Engineering Change Order Log

PDP-8L PROCESSOR LOGIC

EQUIPMENT CORPORATION
ENGINEERING
CHANGE ORDER

CHANGE NO. 8L-00013
DOCUMENTATION PROJECT NUMBER
ACT PROD. LINE TYPE OR DISCRETE NO.

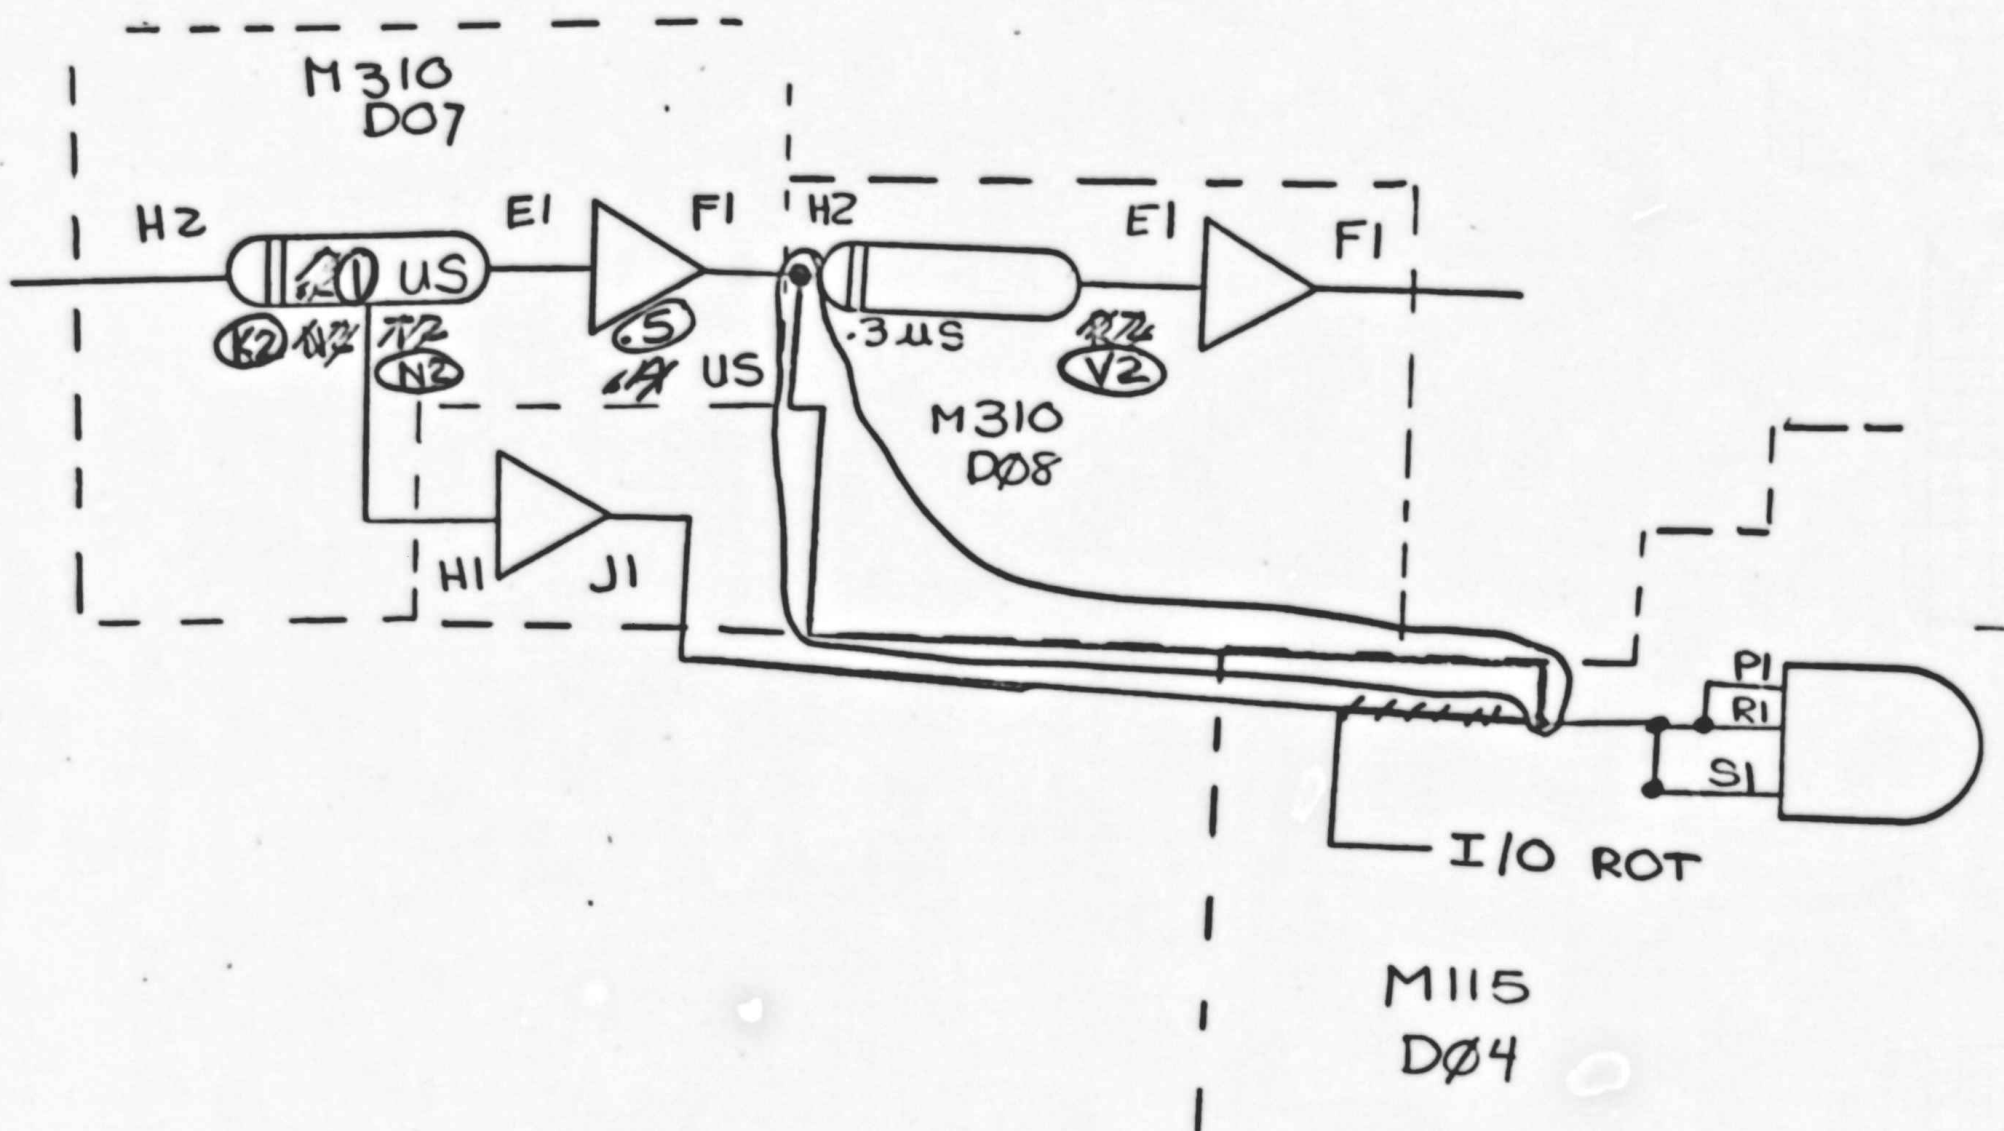
1. RACE CONDITION AT IOP4 CAUSED BY I/O ON (1) AND IOP C (0) BEING GENERATED AT SAME TIME BY I/O ROTATE

NUMBER	OLD REV.	NEW REV.
D-ES-8L-0-2	B	C
K-WL-8L-0-19	B	C

CHANGE NO. 8L-00059

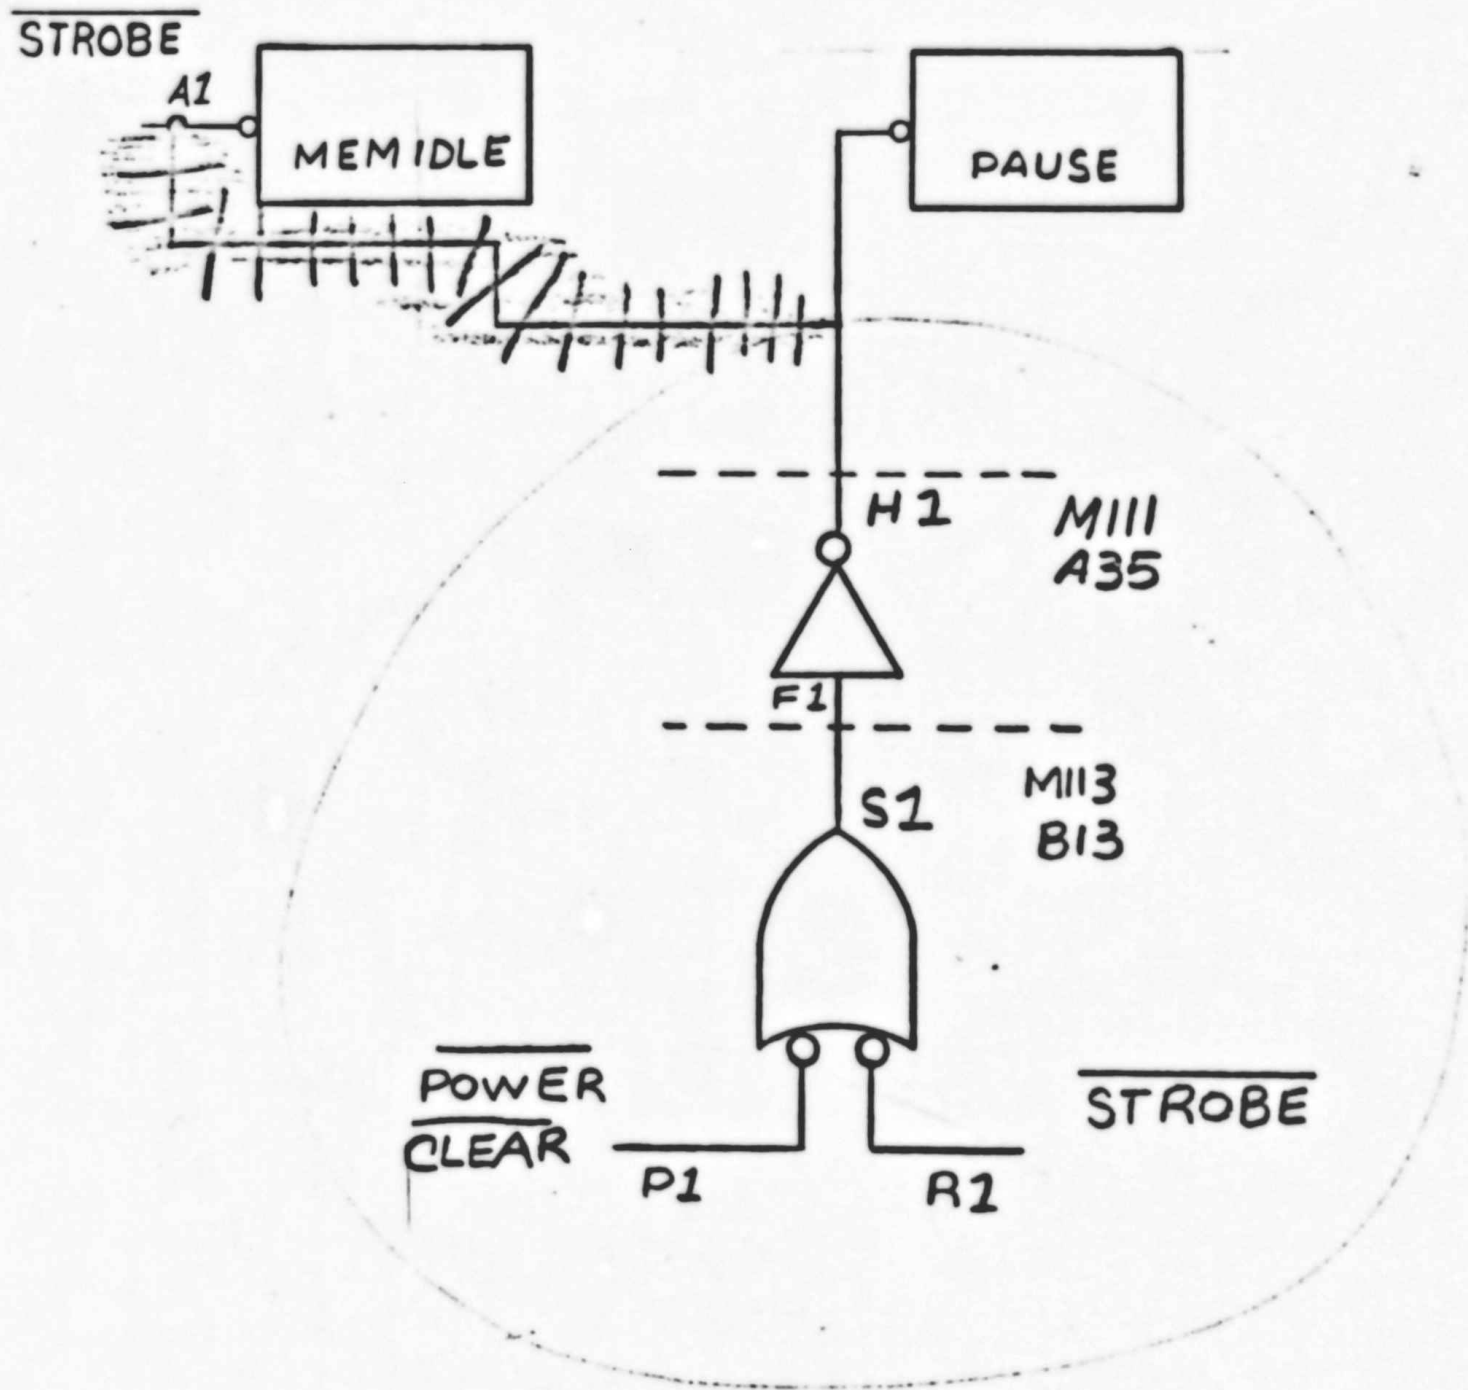
THE PAUSE F.F. CAN COME ON IN EITHER STATE WHEN THE COMPUTER IS FIRST TURNED ON. IF IT COMES UP IN THE "1" STATE, LOAD ADD HAS TO BE HIT TWICE BECAUSE THE PAUSE INHIBITS PC ENABLE.

ADD POWER CLEAR TO PAUSE F.F.

ECO-8L-00078

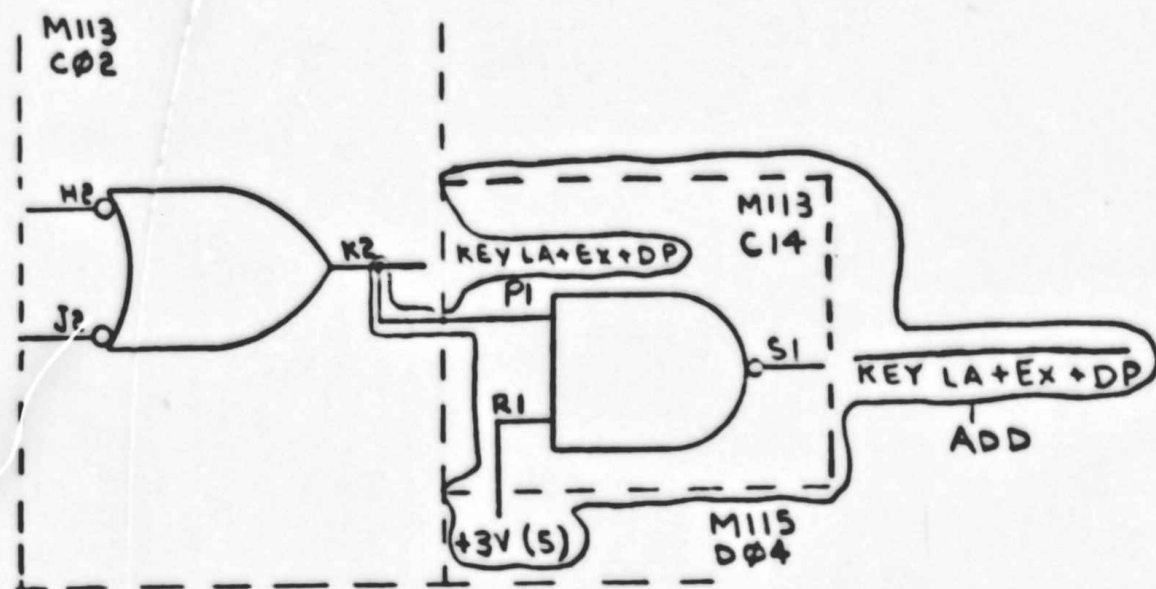
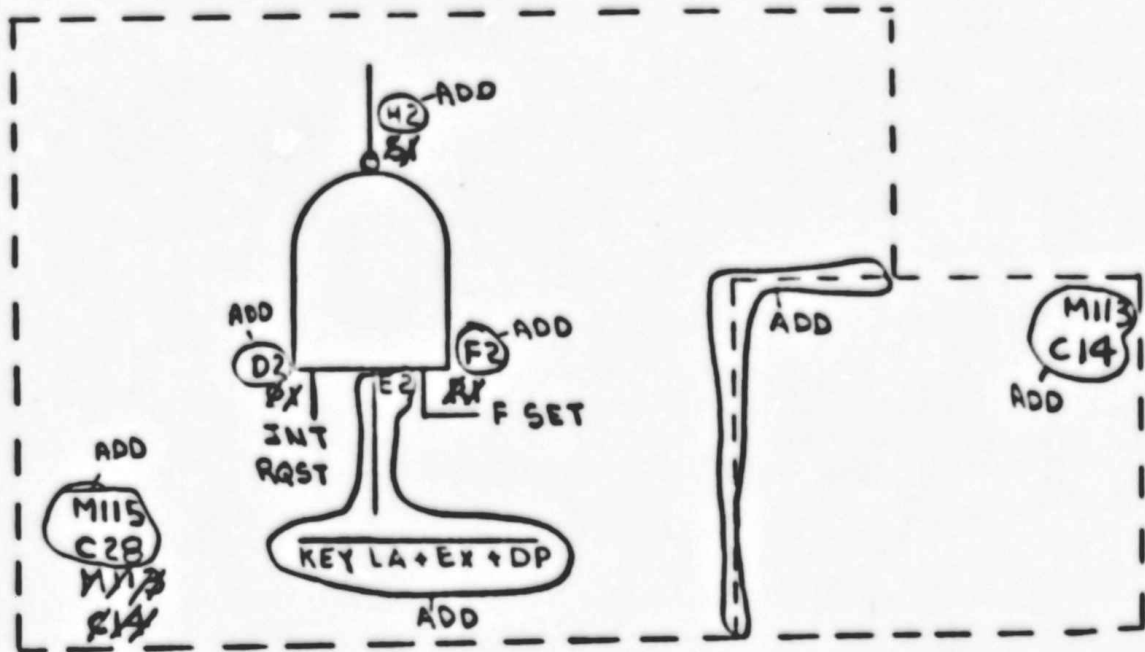
1. ADD KEY LA+EX+DP TO CLEAR INT SYNC, WHEN DOING A KEY FUNCTION.

D-BS-8L-0-2 NEW REV K

BL-00091 A-PL-8L-0-18

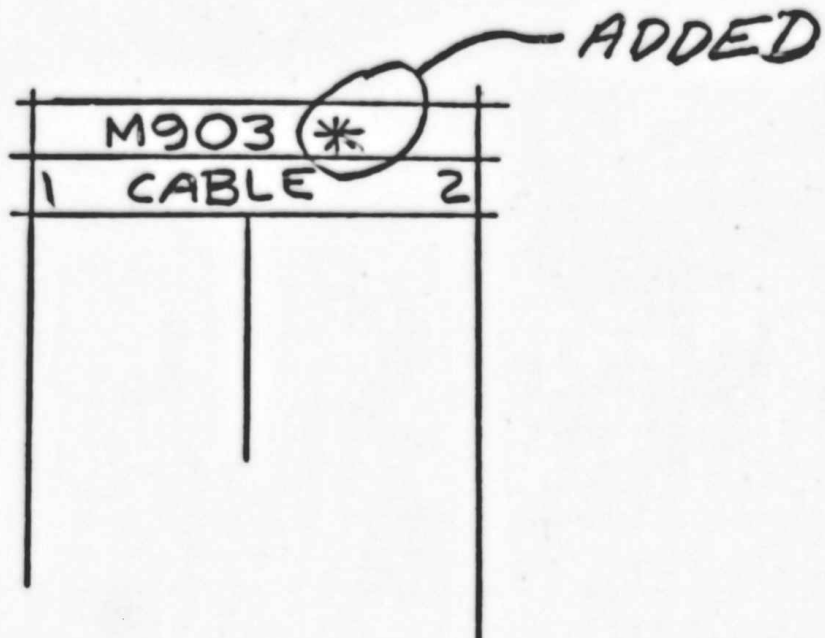
<p>PROBLEM:</p> <p style="text-align: center;">THE G717 (PULSE TERMINATOR MODULE,) IS USUALLY MISSING WHEN OPTIONS ARE INSTALLED ON THE 8L IO BUS.</p> <p>CORRECTION:</p> <p style="text-align: center;">INCLUDE THE G717 AS PART OF THE BASIC MACHINE. ADD IT TO THE 8L PARTS LIST AND MU.</p>	<p>DRAWINGS AFFECTED</p>

ADDED 1 G717 RESISTOR
TERMINATOR FOR PDP-8/L

sheet 2 of 2

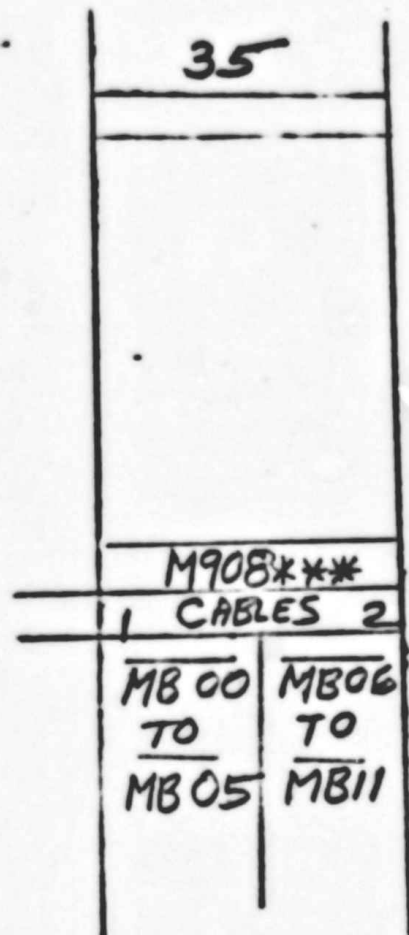
**THE ~~GT~~^{ADD} M902YB (TERMINATOR) IS ALWAYS PLACED AT THE END OF THE IO BUS FOR IOP'S AC BITS AND^{ADD} TIME STATES WHEN ~~20~~^{ADD} FT OR MORE OF CABLE IS USED. WHEN THERE ARE NO OPTIONS THE ~~GT~~^{ADD} M902YB IS PLACED IN LOCATION D36. ^{ADD}

*** THE M902YA IS ALWAYS PLACED AT THE END OF THE IO BUS FOR ALL MB BITS WHEN 20 FT OR MORE OF CABLE IS USED. WHEN THERE ARE NO OPTIONS THE M902YA IS PLACED IN LOCATION D35. ^{ADD}

Title		Tech Tip	
8L AFFECTED BY EXTERNAL NOISE		Number PDP8L TT#7	
All	Processor Applicability	Author	Rev
	8L	W. Freeman	g
		Approval	Date
		W. E. Cummins	11/14/73
		Cross Reference

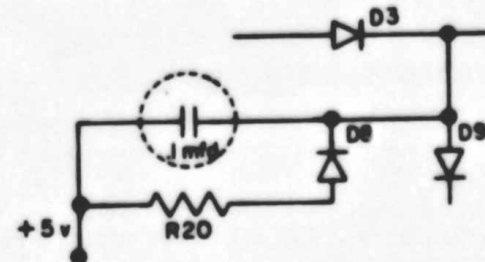
If external noise from surrounding equipment is affecting an 8L, the installation of a .1 mfd. capacitor on the G785 module as shown in the schematic below will resolve the problem.
